Access Compliance Report

Public Rights-of-Way

(Pedestrian Signals)

Intersection ID: N/A	Main Street:	Cross Street: N/A	Location: N/A
ADA ID: 86E90961E27D	Signal Type: One Push Button-APS	Overall Compliance: No	Severity Score: BTN 1: N/A BTN 2: N/A No BTN: N/A
Codes/Mitigation Info/Possible Solution		Field Measurements/Component Compliance

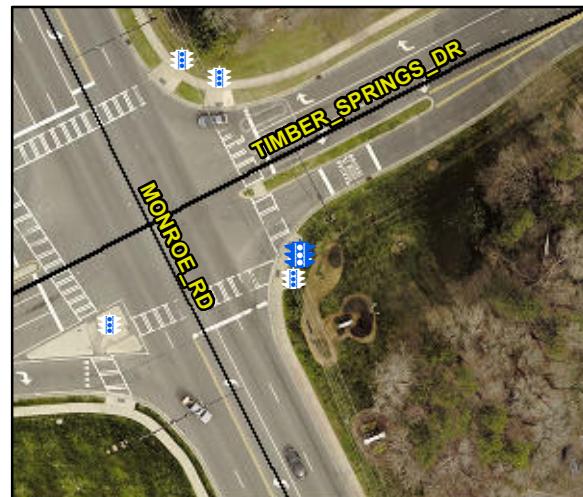
Possible Solutions: Replace Signal Push Button With APS Button on New Post. Remove & Replace Sign.

PROW/ADA: R209.1, TMUTCD 4e.08, R404.2, R406.2, MUTCD 4e.10

Compliance	Description	Data	Compliance	Description	Data
	Button Count	Button1	Yes	Distant to Additional Button (in)	164.0
	Additional Button Present?	Yes		Additional Button ID	10E45CEFF5E0
N/A	Signal Buttons Required?	N/A	N/A	Additional Ped Posts Required	N/A
	How Many Ped Street Xings?	1		Located In An Island/Median?	No
N/A	B 1 Sign Present?	Yes	N/A	B 2 Sign Present?	N/A
No	B 1 Sign Purpose?	No	N/A	B 2 Sign Purpose?	N/A
Yes	B 1 Sign Lettering & Contrast?	Yes	N/A	B 2 Sign Lettering & Contrast?	N/A
Yes	B 1 Parallel To XWalk?	Yes	N/A	B 2 Parallel To XWalk?	N/A
Yes	B 1 PAR to Button?	Yes	N/A	B 2 PAR to Button?	N/A
Yes	B 1 PAR to XWalk?	Yes	N/A	B 2 PAR to XWalk?	N/A
Yes	B 1 Clear Floor Space?	Yes	N/A	B 2 Clear Floor Space?	N/A
N/A	B 1 FWD Approach?	Yes	N/A	B 2 FWD Approach?	N/A
N/A	B 1 FWD Approach Constrained?	No	N/A	B 2 FWD Approach Constrained?	N/A
No	B 1 FWD Approach Reach (in)	10.0	N/A	B 2 FWD Approach Reach (in)	N/A

N/A	B 1 FWD Approach Width (in)	N/A	N/A	B 2 FWD Approach Width (in)	N/A
N/A	B 1 FWD Approach Obstruction?	Yes	N/A	B 2 FWD Approach Obstruction?	N/A
N/A	B 1 FWD Approach Obstruction Dist (in)	2.0	N/A	B 2 FWD Approach ObstructionDist (in)	N/A
N/A	B 1 PARA Approach?	Yes	N/A	B 2 PARA Approach?	N/A
N/A	B 1 PARA Approach Constrained?	No	N/A	B 2 PARA Approach Constrained?	N/A
Yes	B 1 PARA Approach Reach (in)	5.0	N/A	B 2 PARA Approach Reach (in)	N/A
N/A	B 1 PARA Approach Width (in)	N/A	N/A	B 2 PARA Approach Width (in)	N/A
N/A	B 1 PARA Approach Obstruction?	Yes	N/A	B 2 PARA Approach Obstruction?	N/A
N/A	B 1 PARA Approach Obstruction Dist (in)	1.0	N/A	B 2 PARA Approach ObstructionDist (in)	N/A
Yes	B 1 Clear Floor Space Slope (%)	3.3	N/A	B 2 Clear Floor Space Slope (%)	N/A
No	B 1 Clear Floor Space XSlope (%)	4.0	N/A	B 2 Clear Floor Space XSlope (%)	N/A
N/A	B 1 PAR Slope (%)	5.0	N/A	B 2 PAR Slope (%)	N/A
Yes	B 1 Height (in)	40.0	N/A	B 2 Height (in)	N/A

Yes	B 1 Clear Xing Direction?	ClearlyMarked	N/A	B 2 Clear Xing Direction?	N/A
	B 1 Crossing Direction	To NW		B 2 Crossing Direction	N/A
Yes	B 1 DistanceTo XWalk (in)	0.0	N/A	B 2 DistanceTo XWalk (in)	N/A
No	B 1 DistanceTo Curb (in)	78.0	N/A	B 2 DistanceTo Curb (in)	N/A
Yes	B 1 Diameter (in)	2.0	N/A	B 2 Diameter (in)	N/A
